PARTS & SERVICE NEWS CORRECTION

REF NO.	A930245B
DATE	Sept. 3, 1994

SUBJECT: REPAIR OF THE OIL FLOWING OUT OF HYDRAULIC TANK BREATHERS

APPLICATION: WA600-1 Wheel Loaders, S/N 11140 thru 11305 (except 11300 and 11301)
WA600-1 Wheel Loaders, S/N A10391 and up
WA600-1LC Wheel Loaders, S/N A50001 and up

Parts to be fabricated in the field

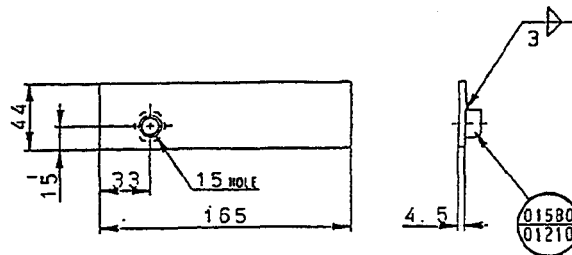
Part No.: GI62-208-02
Part Name: ANGLE
Material: SS400A
Q'ty/Machine: 1

Part No.: GI62-208-01
Part Name: PLATE
Material: SS400F
Q'ty/Machine: 1

3. Improvement details

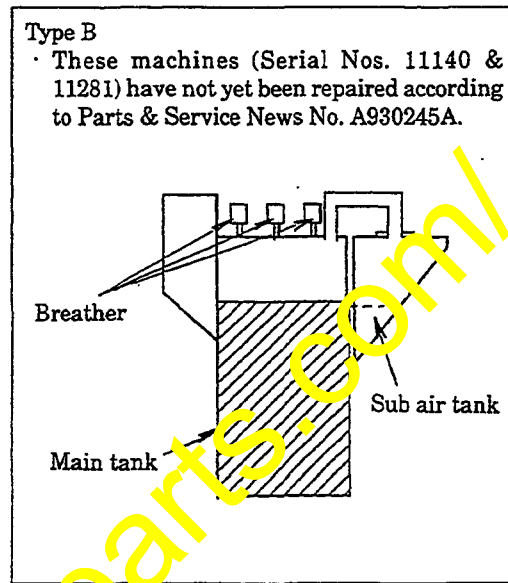
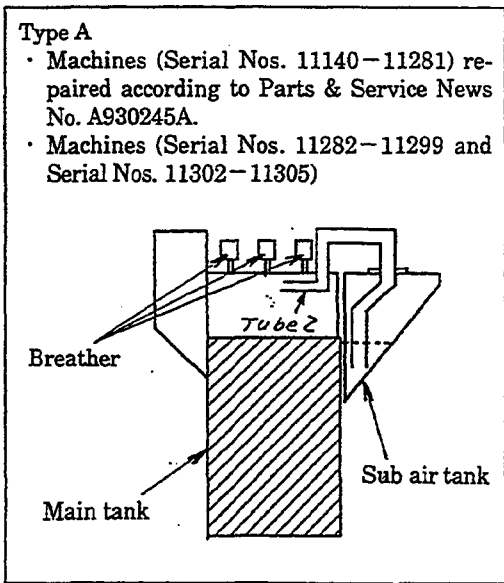
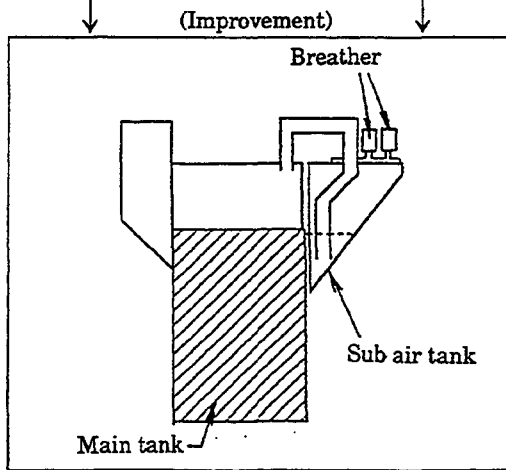
There are 2 types (A and B) of piping between the main hydraulic oil tank and the sub air tank depending on machines.

- ① Abolition of orifice tube (tube 2)
- ② Relocation of breathers from main oil tank onto tube (sub air tank) side

- ③ Lower tube tip on sub air tank side to tank bottom.
- ② Relocation of breathers from main oil tank onto tube (sub air tank) side

- ① Abolition of orifice tube: for full air circulation between main oil tank and sub air tank.
- ② Relocation of breathers: Breathers are relocated onto the sub air tank side where the tank internal pressure does not exceed the breather discharge pressure, even when peak pressure is built up in tank.
- ③ Lowering the tube tip to the bottom of the sub air tank: Even when oil remains in the sub air tank, if the boom is raised, the oil will be drawn out to the main oil tank side due to the difference in internal pressures (internal pressure in main oil tank will be lower than that in sub air tank).

Type A repair procedure

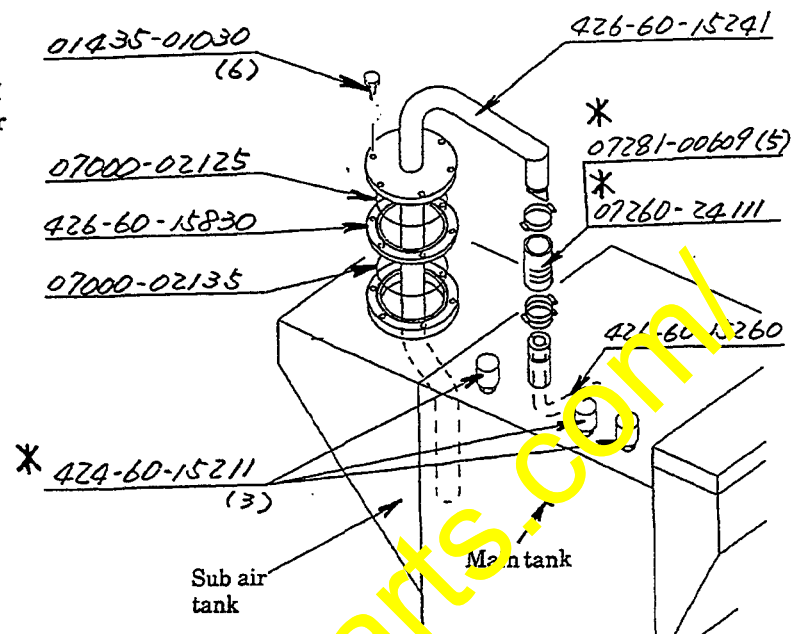
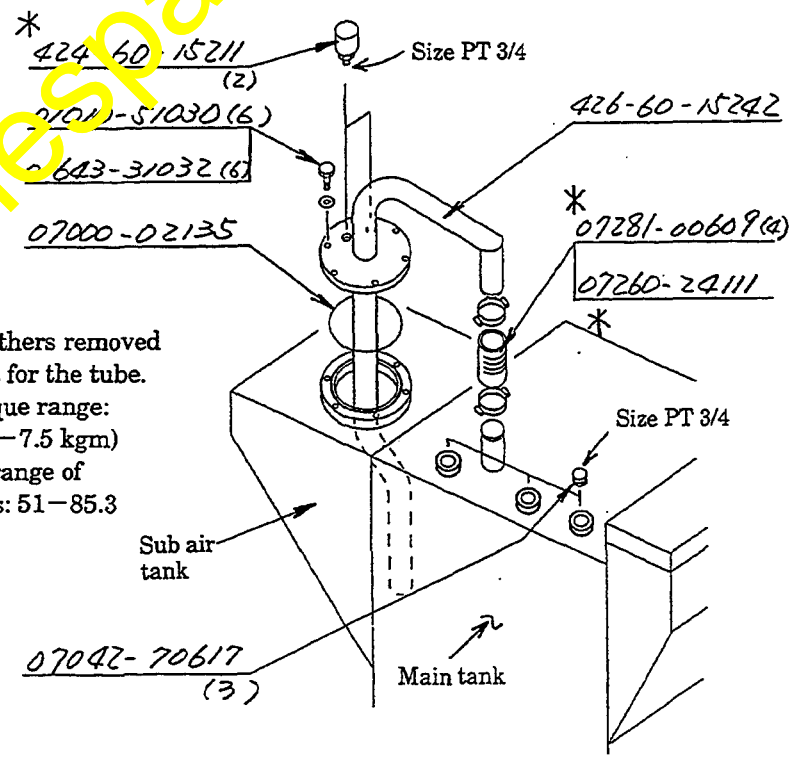
- a. Remove the parts shown at the right. The parts marked * should be reused for repair.

- b. Install newly-prepared tube (426-60-15242). The breather mount positions should be changed from the main oil tank to the tube (sub air tank) side. Then, insert blind plugs (07042-70617, 3 pcs.) into the former breather positions.

- Note 1) Use two of the breathers removed in (a), and 4 clamps for the tube.
- Note 2) Tightening torque range: 68.0 - 73.5 Nm (6.0 - 7.5 kgm)
- Note 3) Tightening torque range of breathers and plugs: 51 - 85.3 Nm (5.2 - 8.7 kgm)

Type B repair procedure

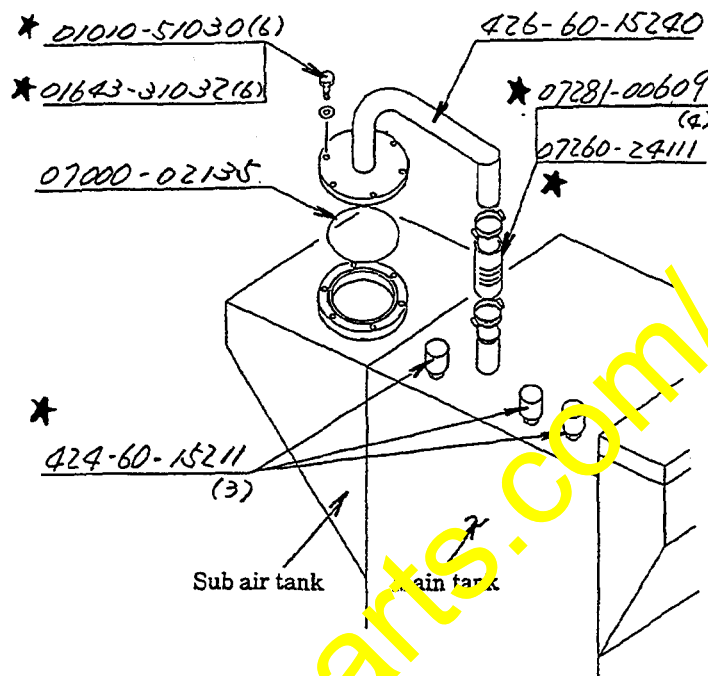
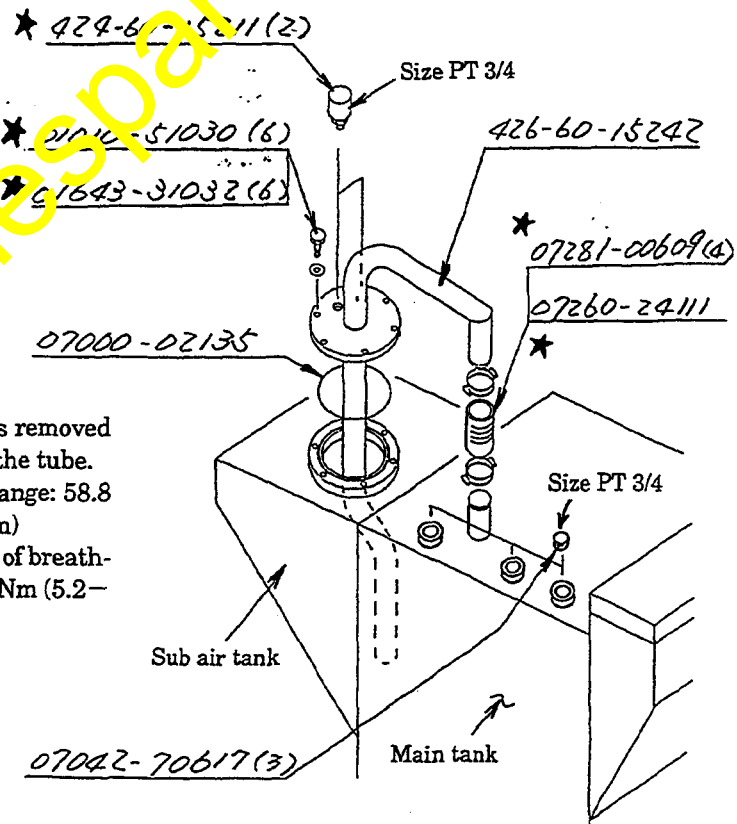
- a. Remove the parts shown at the right. The parts marked ★ should be reused for repair.

- b. Install newly-prepared tube (426-60-15242). The breather mount positions should be changed from the main oil tank to the tube (sub air tank) side. Then, insert blind plugs (07042-70617, 3 pcs.) into the former breather positions.

- Note 1) Use two of the breathers removed in (a) and 4 clamps for the tube.
- Note 2) Bolt tightening torque range: 58.8 – 73.5 Nm (6.0 – 7.5 kgm)
- Note 3) Tightening torque range of breathers and plugs: 51 – 85.3 Nm (5.2 – 8.7 kgm)

5. Reworking procedure (Reworking of R.H platform)

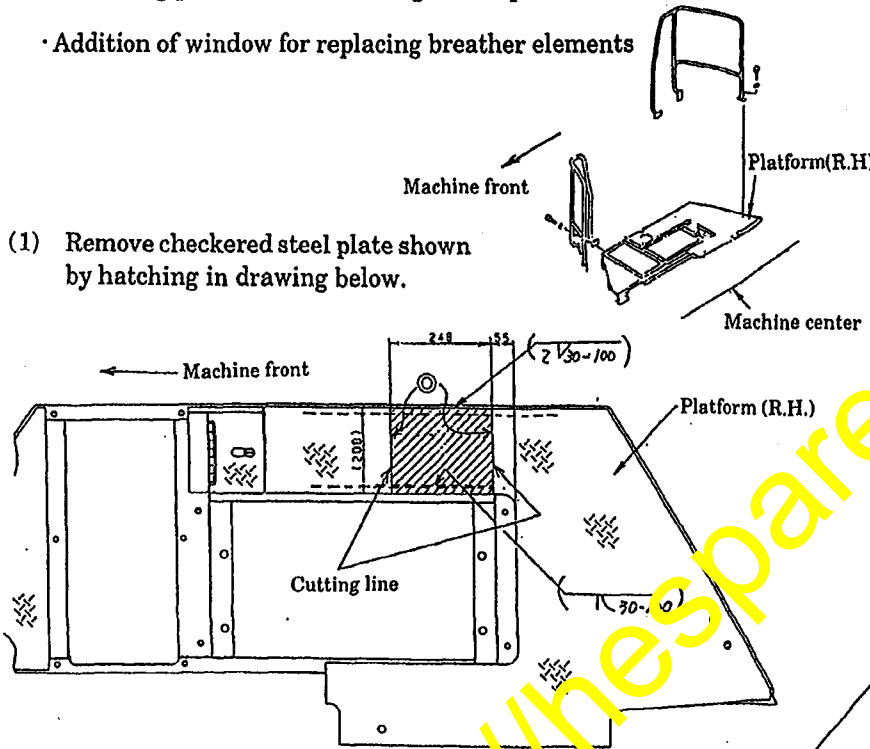
- Addition of window for replacing breather elements

(1) Remove checkered steel plate shown by hatching in drawing below.

- Cut along the dimensions indicated above with a grinder. Further, cut the weld beads with a grinder to remove the hatched portion (checkered steel plate).

Note 1) Remove burrs from the faces marked © on above drawing with grinder.

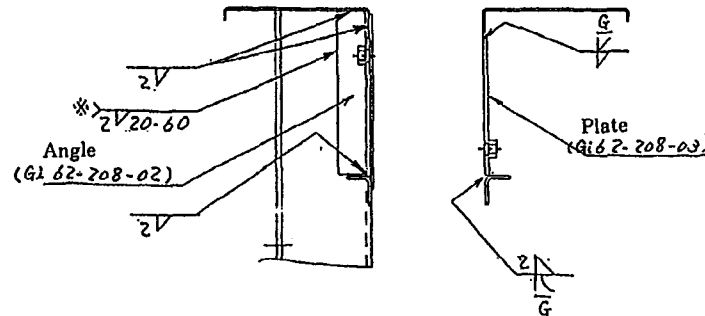
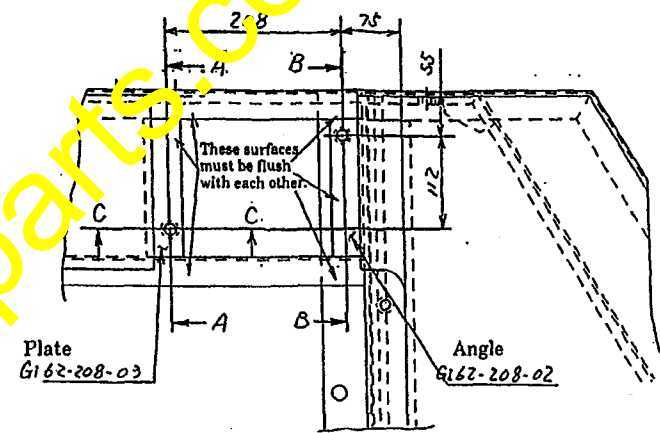
(2) Weld plate (GI62-208-03) and angle (GI62-208-02) according to the dimensions indicated below.

Note 2) In the welding zone marked ※ in the drawing, the ends must be welded without fail.

Note 3) After reworking, perform touchup painting. (PT-3 Blue E2)

6. Installation of platform

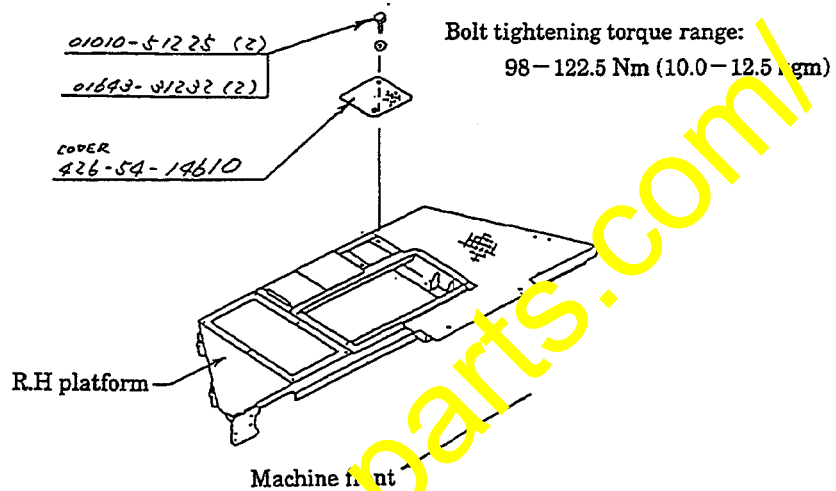
- (1) After reworking, install the platform on the chassis. (The mounting parts should be reused.)
Bolt tightening torque range: 98 – 122.5 Nm (10.0 – 12.5 kgm)
- (2) Installation of platform cover
(Installation of cover for replacing breather elements)
